To: UNFCCC Secretariat  
Martin-Luther-King-Strasse 8  
D-53153 Bonn  
Germany

Please find below our response to the issue raised by request for review of the “**Heilongjiang Yilan Hezuolinchang Phase II Wind Power Project**” (UNFCCC Ref. No. 2117).

**Figure 1 Trends for the tariff of the projects commenced after 2002 in Heilongjiang province**

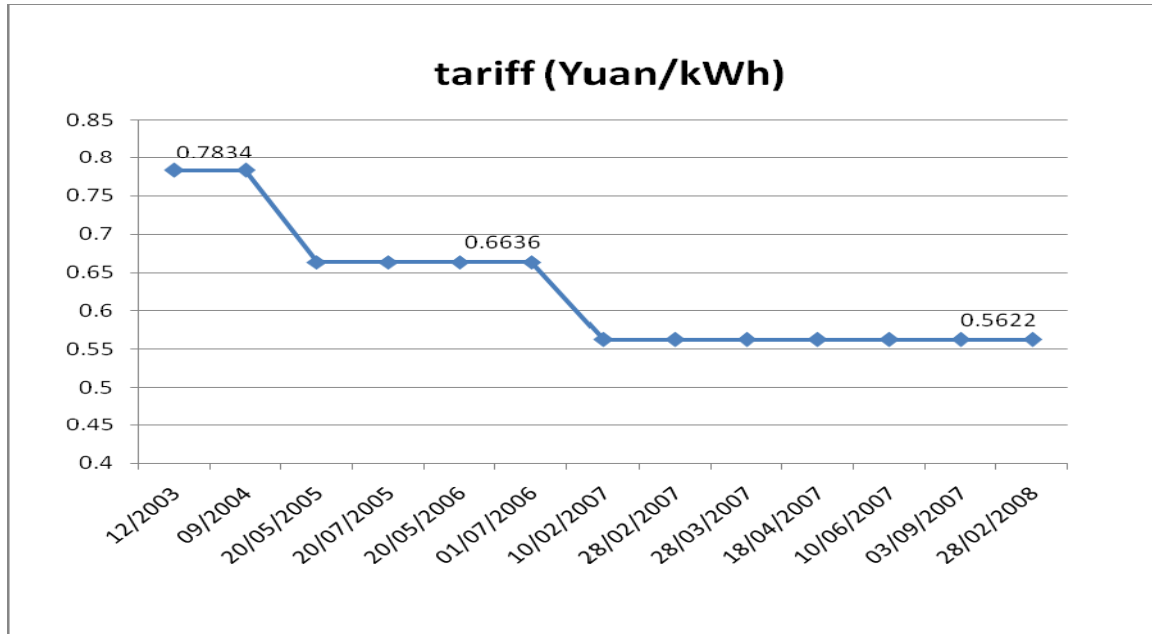
*Question 2. The DOE is requested to confirm the appropriateness of the electricity tariff assumed in the PDD, in comparison with previous tariff notifications for similar projects in the same region which commenced since 2002 and whether such information was available at the time the FSR was prepared.*

As the Figure 1 indicated, the tariff for the projects exporting electricity to the same grid, which commenced after 2002, has decreased from 0.7834 to 0.5622 Yuan/kWh (Excluding VAT). The proposed project is definitely in line with the general decreasing trend.
